RE: 9365 Fields Ertel Road Zone Change

We have received the Staff Report for Symmes 2021-01 at 9365 Fields Ertel Road, a Major Revision to an existing "EE" Planned Residence (with Subservient Retail) (Case Symmes 88-5) and zone change from "OO" Planned Residence to "EE" Planned Residence. The Staff Report recommends approval with eight (8) conditions, which are addressed below.

NEW SIGN PLANS

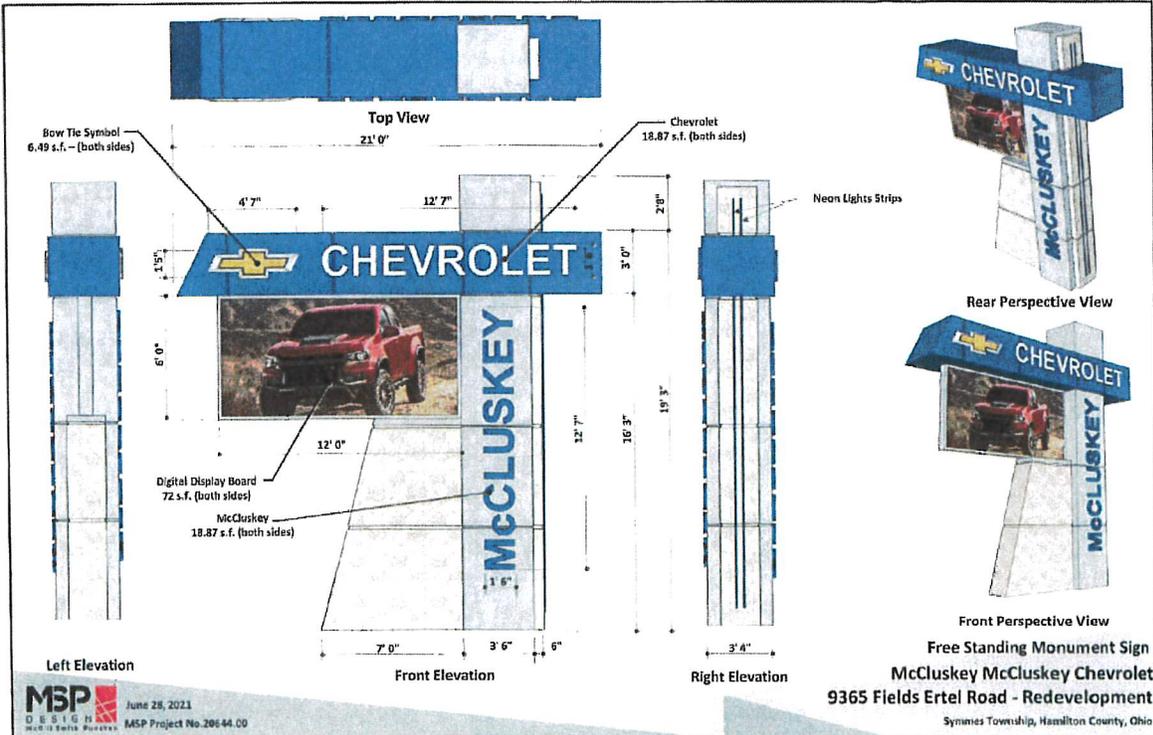
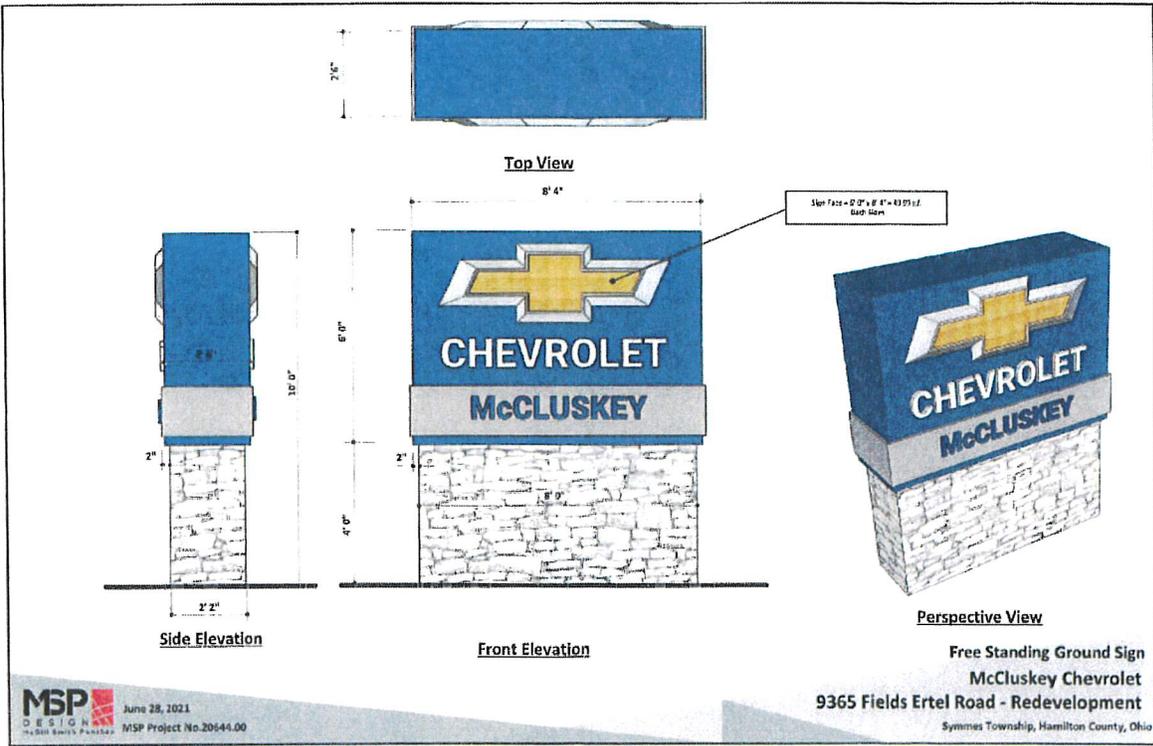
Condition No. 3: *That a detailed signage plan in compliance with the Zoning Resolution shall be submitted as part of the Final Development Plan.*

Condition No. 4: *That the site shall be permitted a maximum of two freestanding monument signs with a maximum height of 10 feet and a maximum area of 50 square feet and that such signs shall be in compliance with all other freestanding sign requirements of the Zoning Resolution.*

Applicant Response: A detailed Signage Plan has been developed and provided as an exhibit. Below, please find the excerpt from the Symmes Township Zoning Resolution which applies to freestanding ground mounted signs within the E and EE Districts:

The applicant will erect three free standing ground mounted signs at each access point (one at Union Cemetery Road and Governor's Way, One at the new Access along Fields Ertel and One at the new Access along Montgomery Road) with each sign being 10' in height with a maximum of 50 s.f. of sign face (max. 2 sides) and be placed no closer than 10' from either a "right of way" line or an adjacent property line. In addition, a free standing monument sign (Ground Sign) has been proposed at the intersection of Fields Ertel Road and Union Cemetery Road that would replace the existing 30' x 10' pylon sign. This an extremely important corner and a gateway into our project and the proposed sign provides a contemporary sign aesthetic. There will be a variable message center (VMC) sign component for the aforementioned ground mounted sign set to replace the existing pylon sign (300 s.f.). The VMC is measured at 72 square feet, which will comprise 24% of the sign and complies with the zoning resolution (a VMC may not be larger than 25% of the sign face). The applicant will comply with all other regulations applicable to VMCs.

Calculation: Proposed Square Footage of Wall Signage for this Project. See proposed building sign exhibit illustrating conformance to the zoning criteria of Section 321.4. The proposed building signage is as follows:

In summary, the applicant will comply with all signage standards with the exception of the freestanding monument sign at the corner of Fields Ertel Road and Union Cemetery Road. For this individual sign, the applicant is seeking only the amount of signage area that was permitted for the previous business on the property. The signage that the applicant seeks to erect is scaled appropriately for this site and is in keeping with the signage dimensions that have been approved for adjacent business owners.

PARKING DISTRIBUTION EXHIBIT

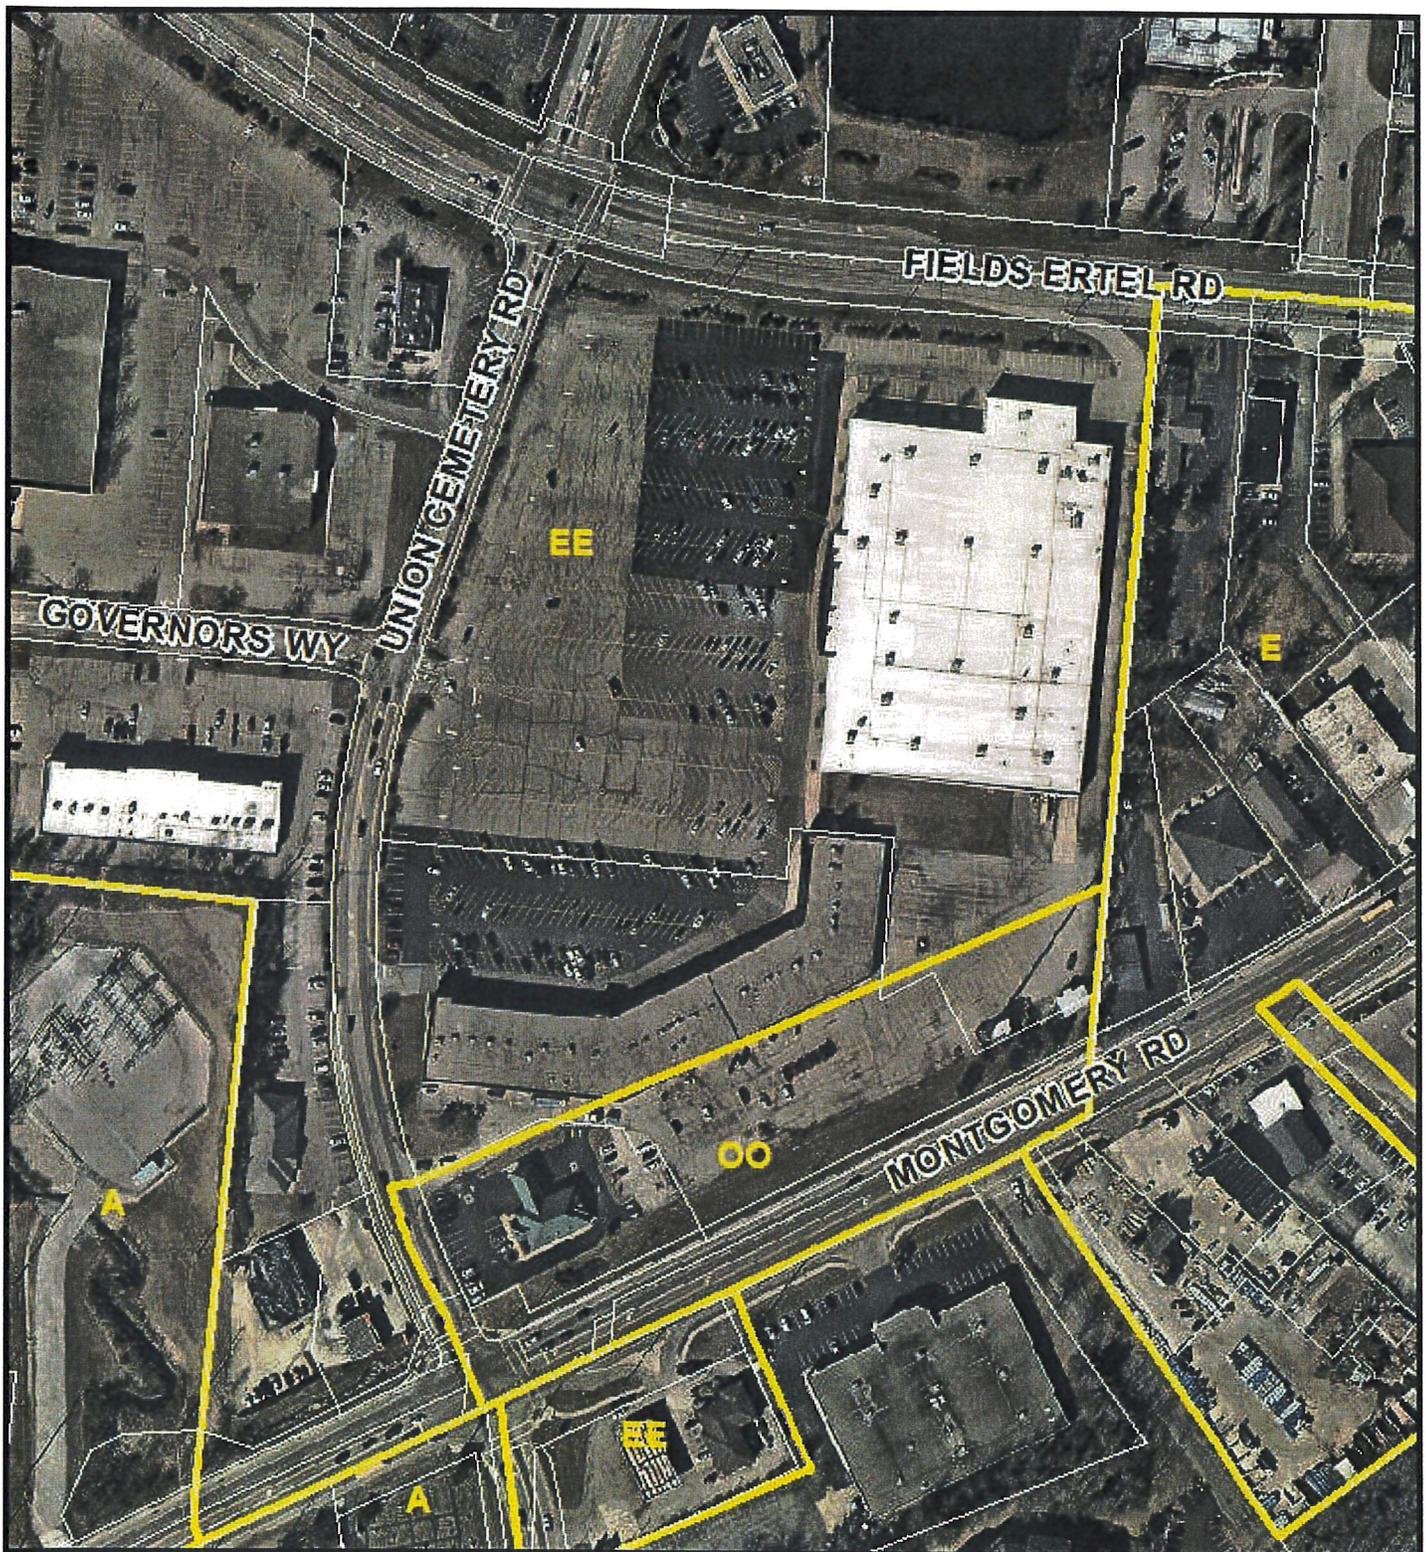
Condition No. 7: That the areas dedicated to vehicular display shall not include any required parking spaces and shall be identified on the Final Development Plan.

See the Parking Distribution Exhibit showing the parking allocations New Car Display, Used Car Display, Customer/Employee and Flexible parking spaces that can be used according to the needs:

New Car Display:	404
Used Car Display:	265
Customer/Employee:	324
Flexible Spaces	99 (Can be used for car display or for Customer/employee)
Total Spaces	1,092
